09 February 2026

211541 CAAL

173-179 Walker Street, North Sydney

Proposed Changes to Early Works Stormwater Diversion (SSD-67175465)

TYPICAL CUSTOM PIT DETAILS

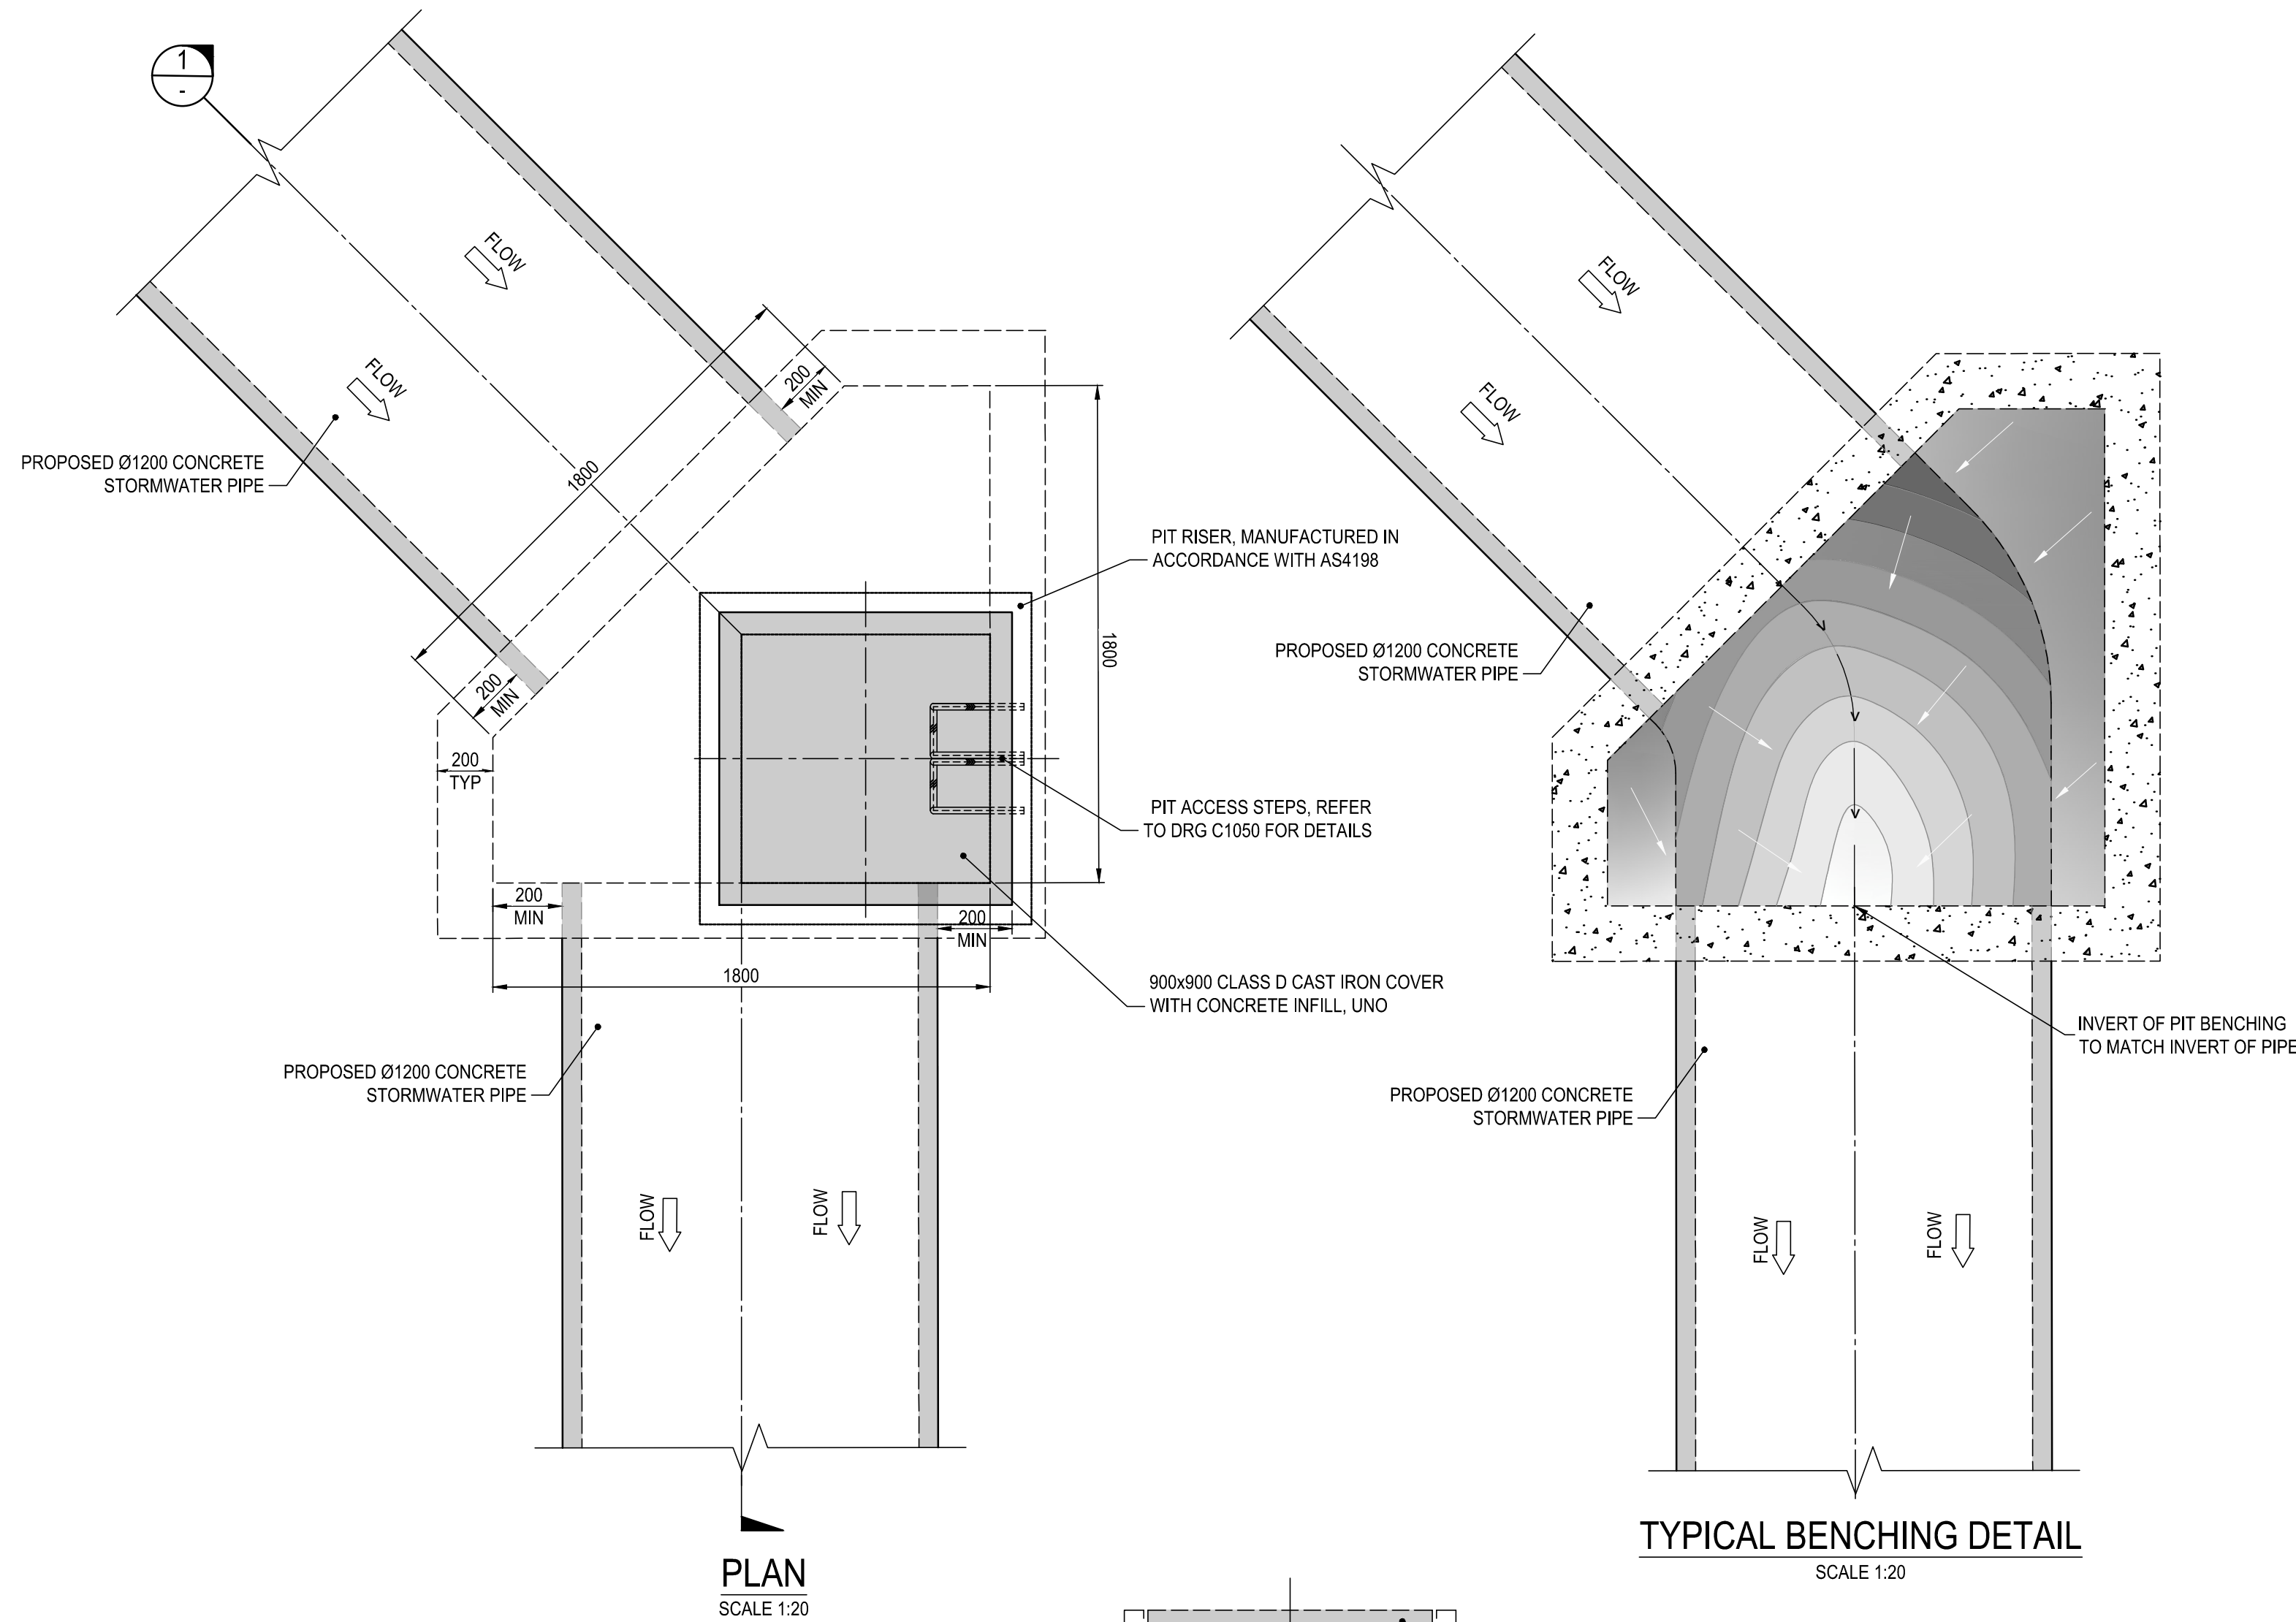
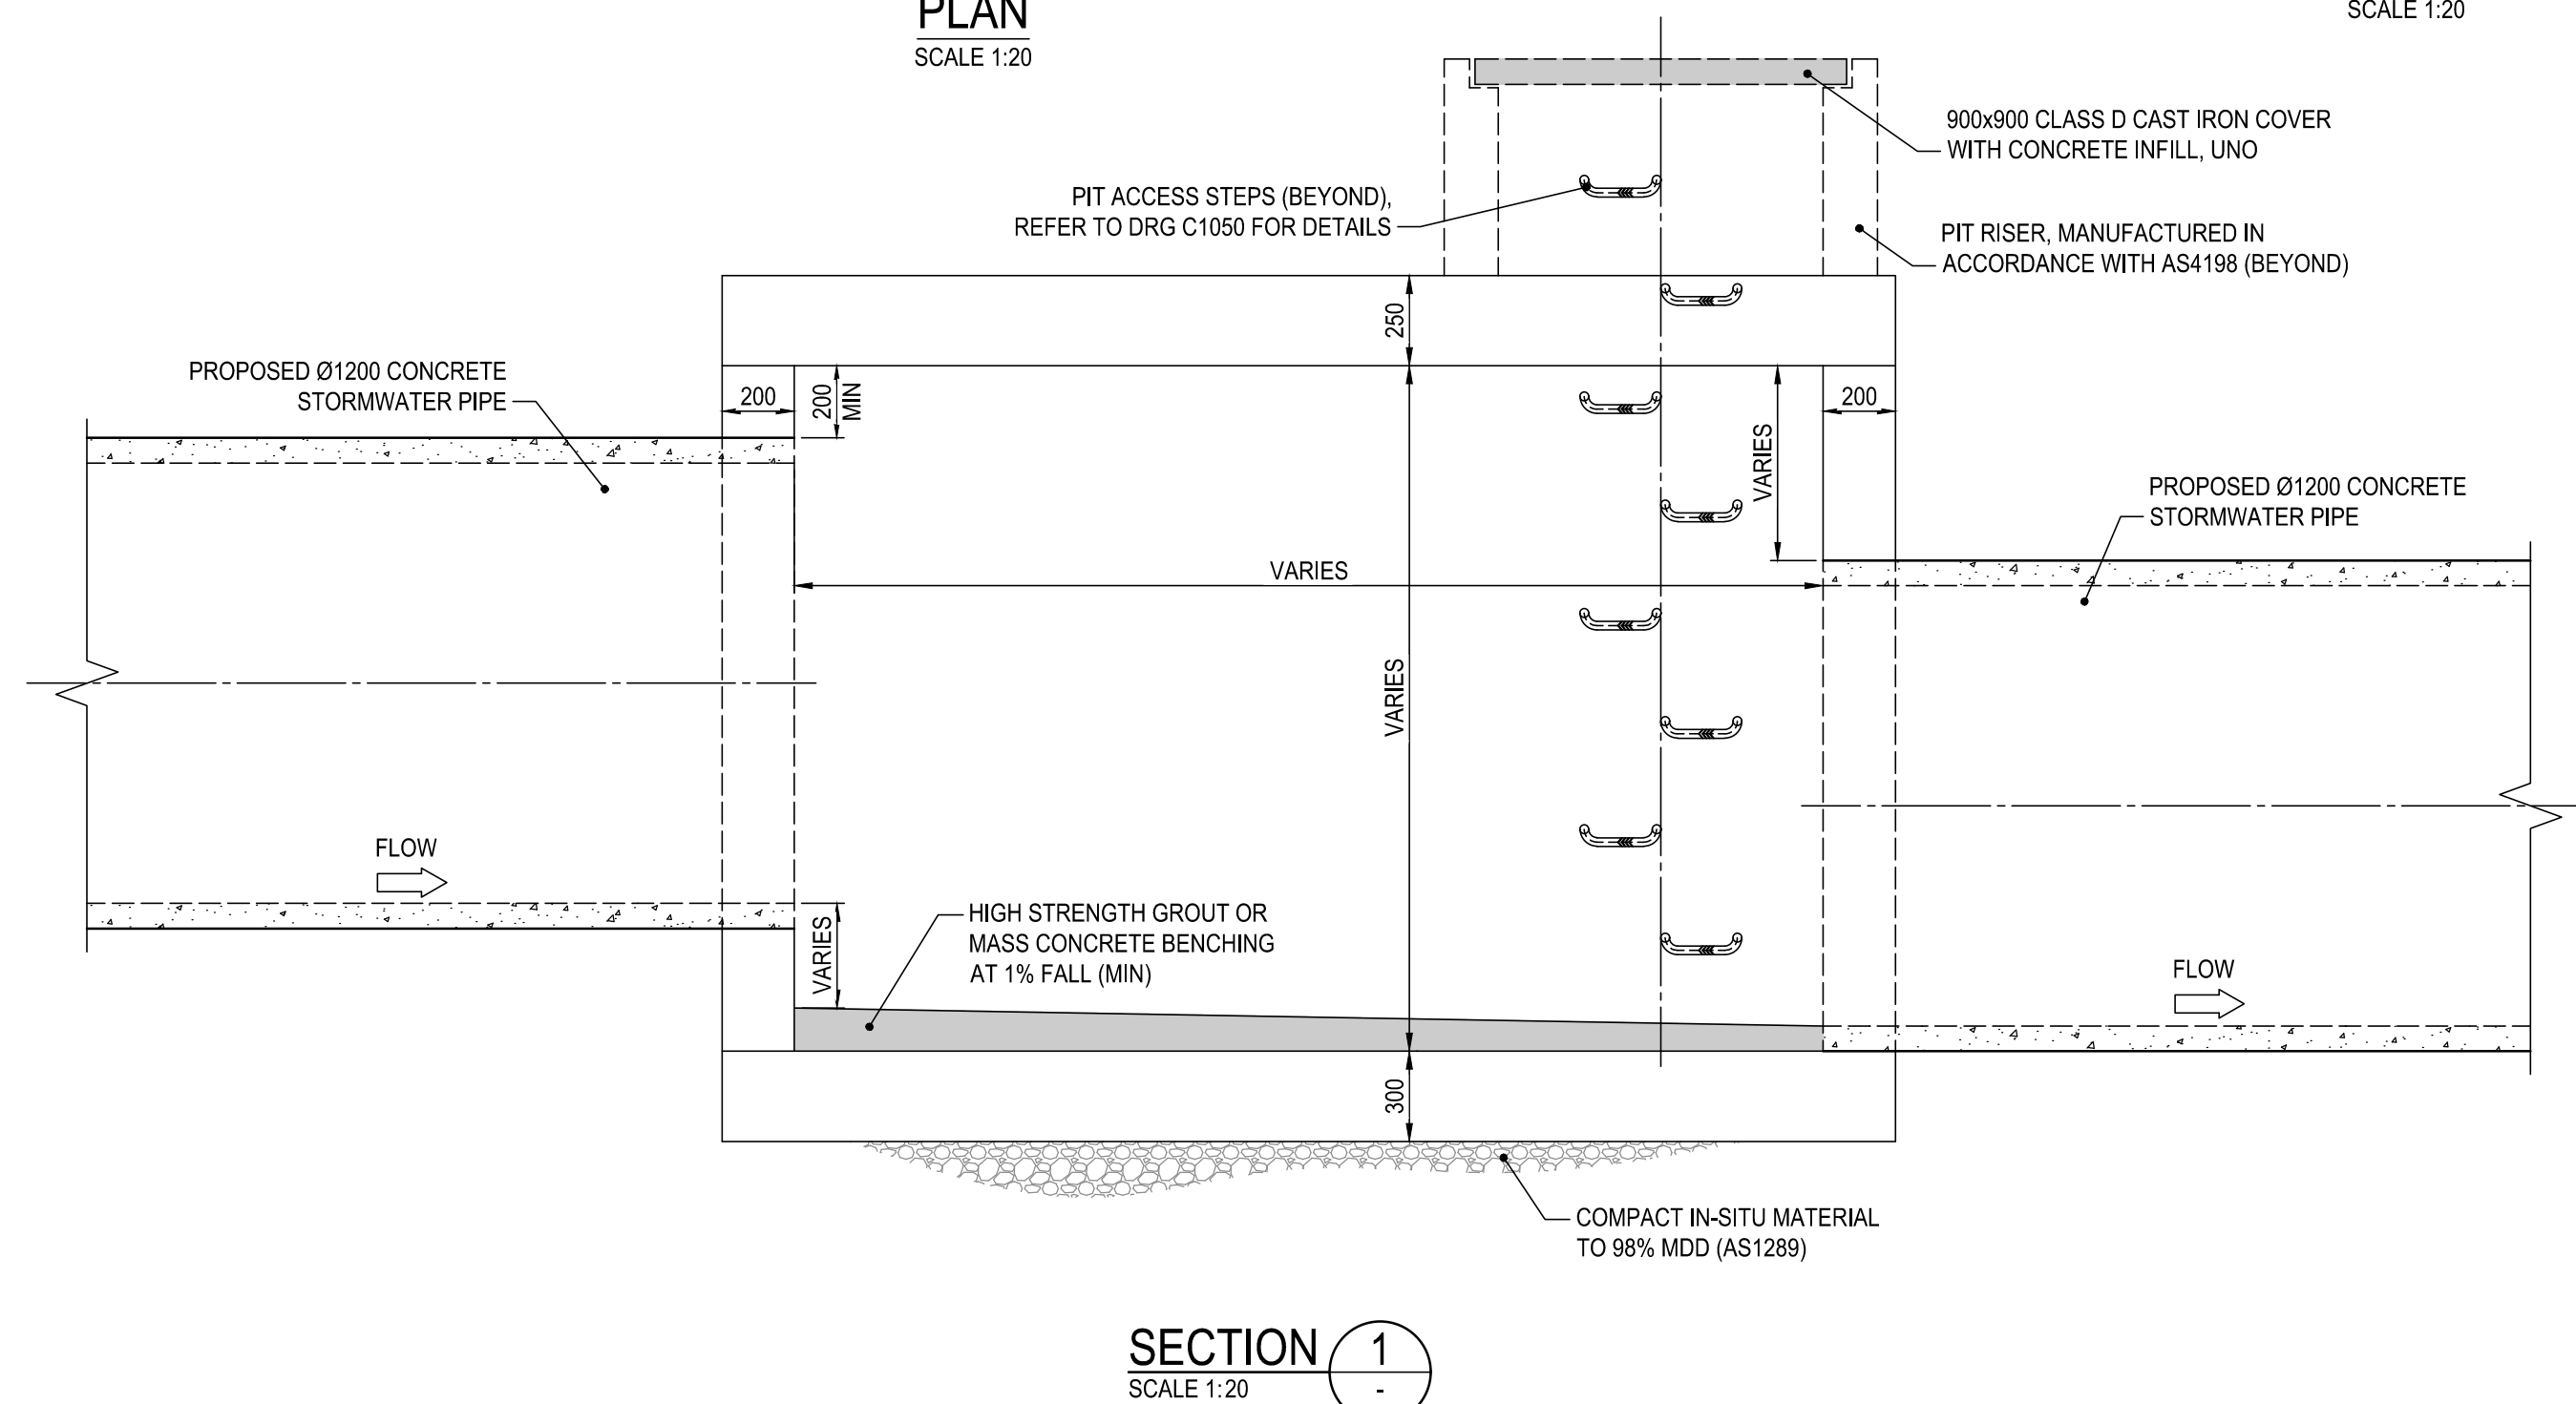
1. Relocation of Proposed 5-Grate/Lintel Pit with Stone Inlet (Pit 7A)

Site investigations have confirmed that the existing 860mm × 1000mm box culvert traverses the site in a perpendicular alignment to the retaining wall, rather than the diagonal alignment shown on the original survey. To reflect the confirmed culvert alignment, reduce on-site construction complexity, and utilise existing pits to achieve a direct connection, it is proposed to relocate Pit 7A directly over the existing box culvert.
